From: Flood Risk Management <floodriskmanagement@manchester.gov.uk>
Sent: 09 March 2021 17:31
To: Marta Wolska
Subject: RE: Hammerstone depot Manchester

Connection to southern watercourse

North watercourse Corn Brook

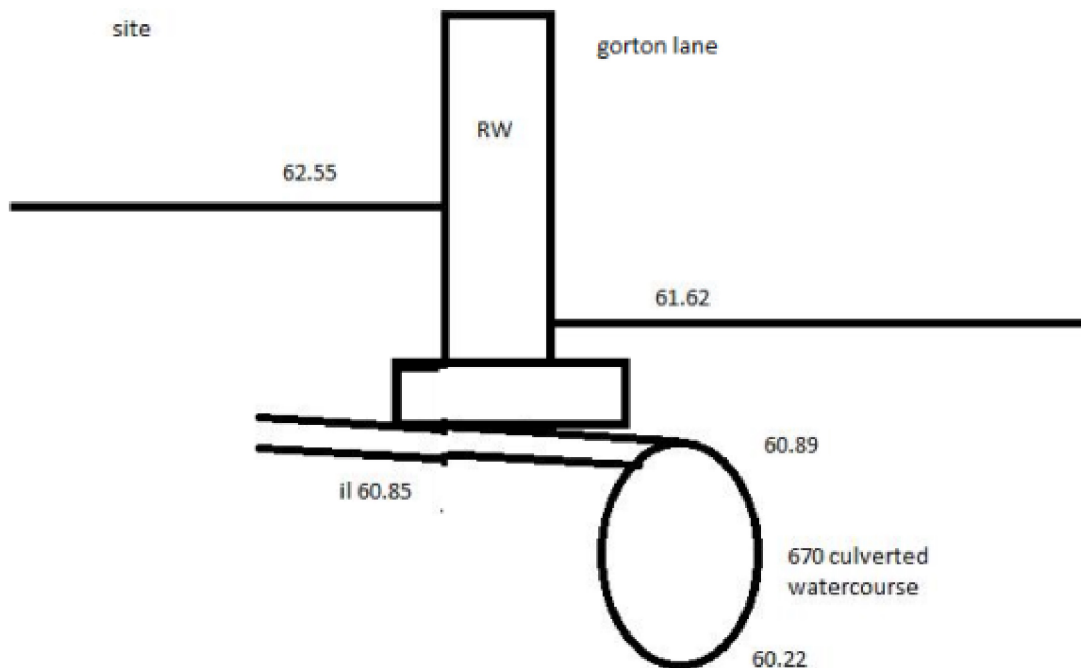
The existing south car park and existing building discharge currently to a combined water sewer within Gorton Lane. The southern culverted watercourse based on UU records runs under and near existing retaining wall. The southern culverted watercourse could not be traced as the covers could not be lifted using hydraulic lifters. Based on UU records the culverted watercourse is quite shallow, invert level is 1.4mbgl, whereas soffit 0.73m. the expected bottom of retaining wall foundation is 0.60mbgl, which means that proposed pipe soffit will be straight below existing retaining wall foundation.

The condition of the retaining wall is clearly in a state of disrepair and as such any works carried out to the wall may affect the ongoing structural integrity of the wall itself which may extend beyond the localised works required to form any new connection. Coupled with this, there is the ongoing maintenance of the pipe work between site and the culvert which must be considered - any settlement to the wall at a critical drainage location could damage the pipe and affect the performance of the overall drainage system to the wider site.

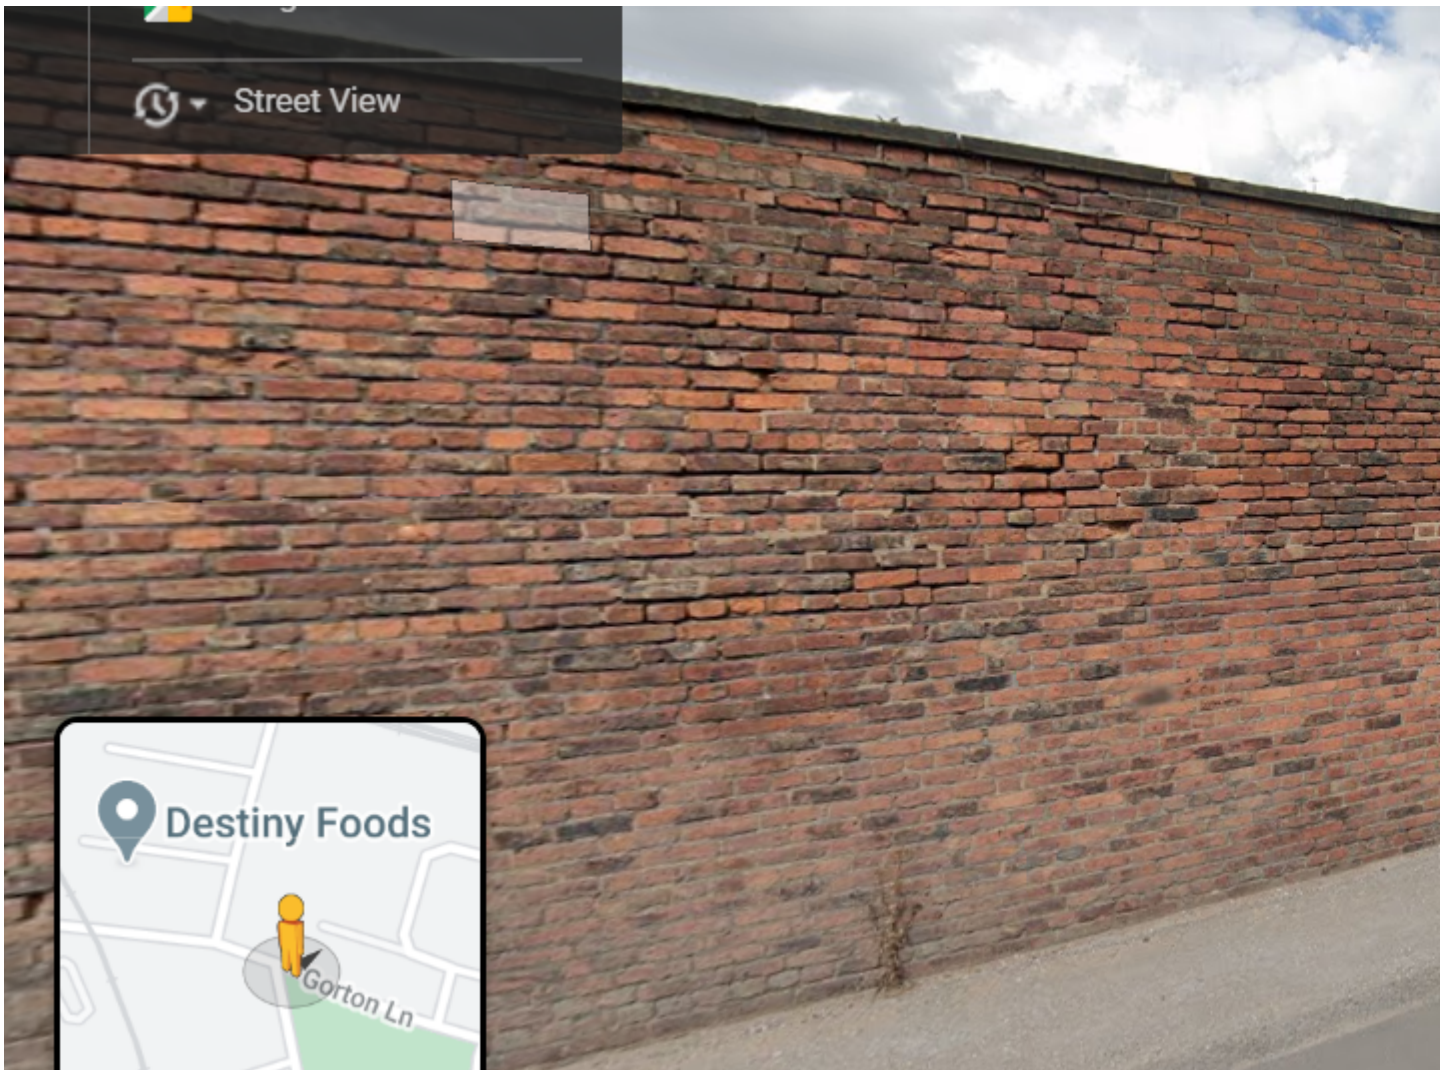
This would also cause major issues with the foundations to the wall and the depth of the connection

We propose to reuse the existing connection from site to combined water sewer with restriction more than 50% reduction for lower car park .Could you please advise if that would be acceptable?

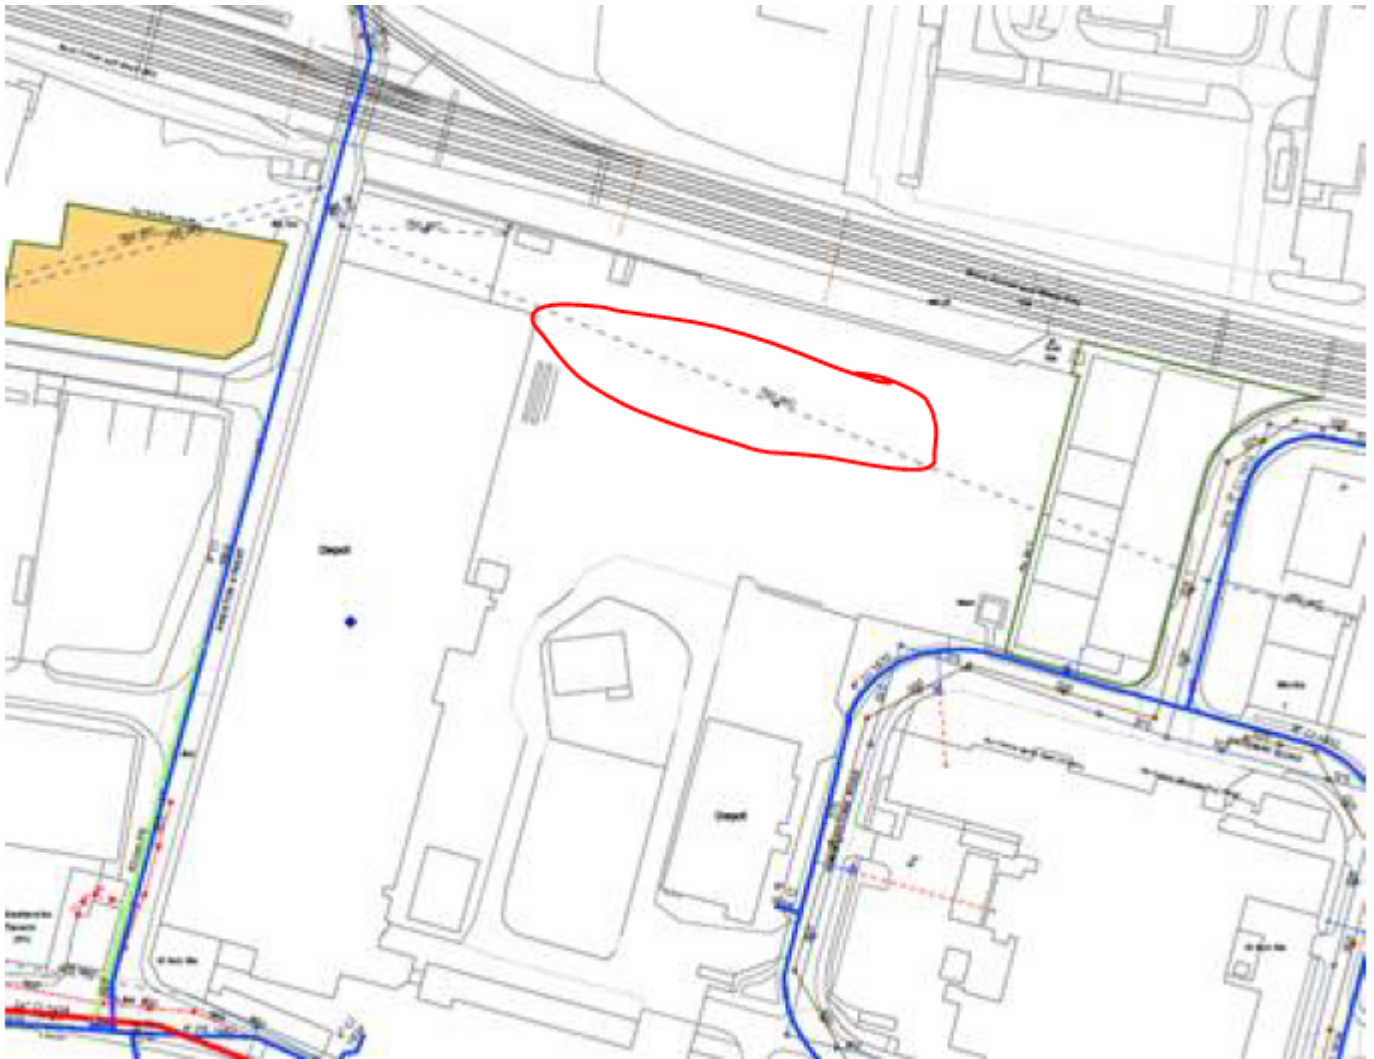
Please find attached email where my colleague asked you regarding culverted Corn Brook watercourse within our site. I could not find in that email who is responsible for maintenance and repairs of the culverted Corn Brook within our site. Could you please confirm who is the owner of the culvert within our site and who is responsible for maintenance and any repairs.
